Permit Revision Submittal Requirements and Application

OHSU Hospital Expansion Project

Subject: Permit No: 19-250474-reREV-01-CO

Permit Revision Narrative

Figure 1-1

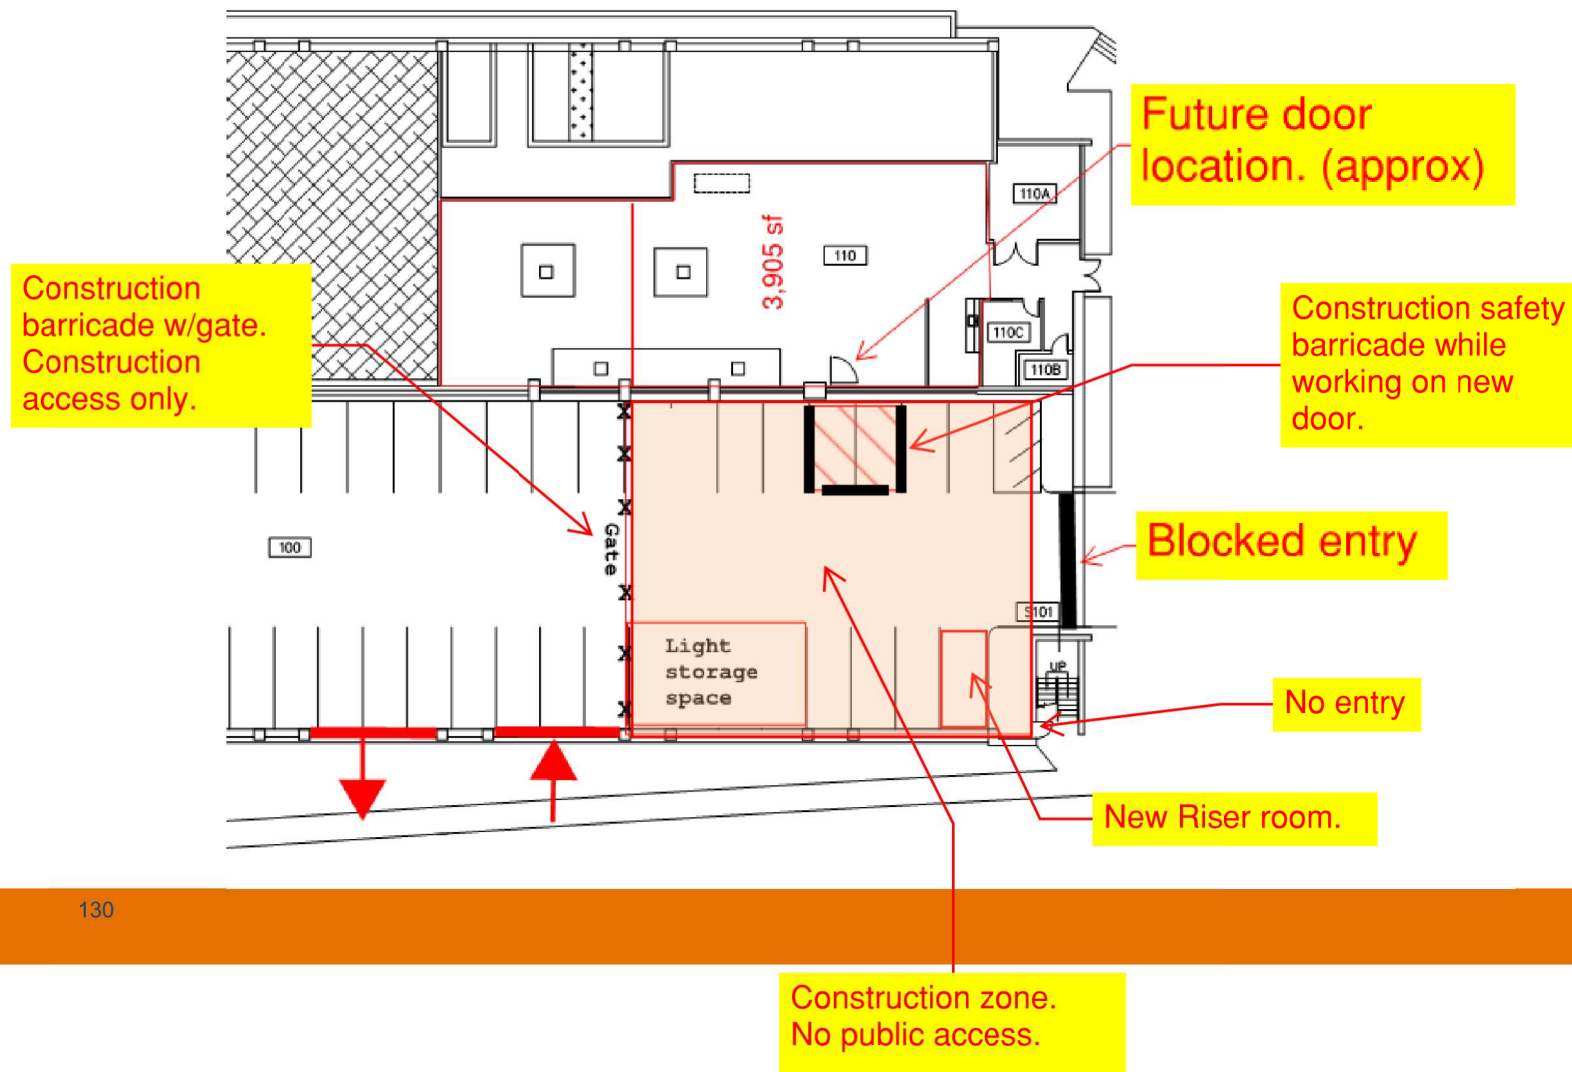
The scope included within this package is as follows: Provide a new opening at level 1 from the parking garage to storage area and construct a new riser room. These scope items will be constructed within the parameters of the OHEP IPA jobsite, behind the construction barricades. This will keep pedestrians and any OHSU hospital staff or patients clear of any construction activity. (See figure 1-1)

Figure 1-2

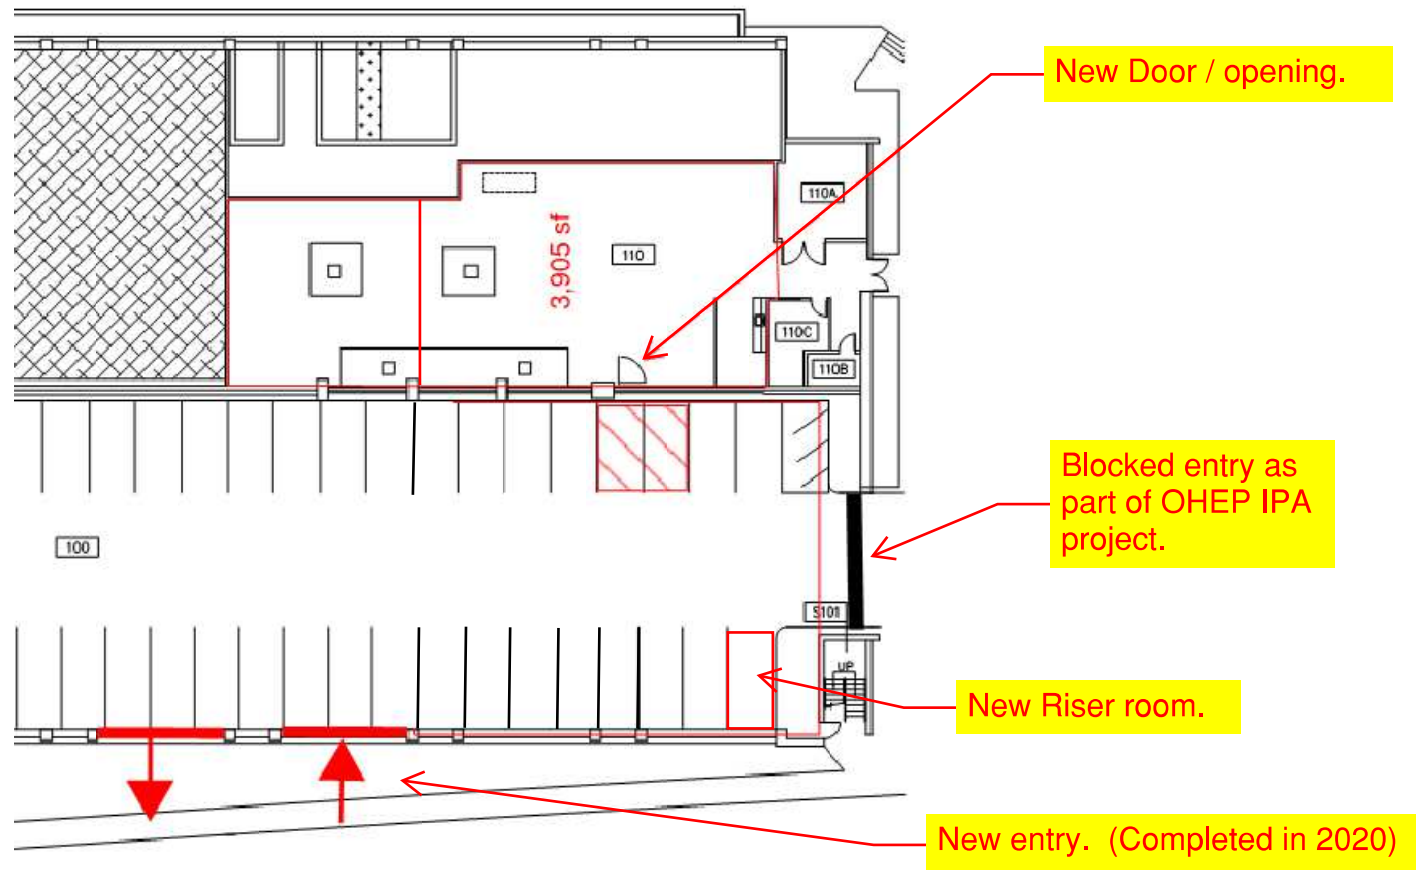
(Figure 1-2) shows the final configuration once the work has been completed.
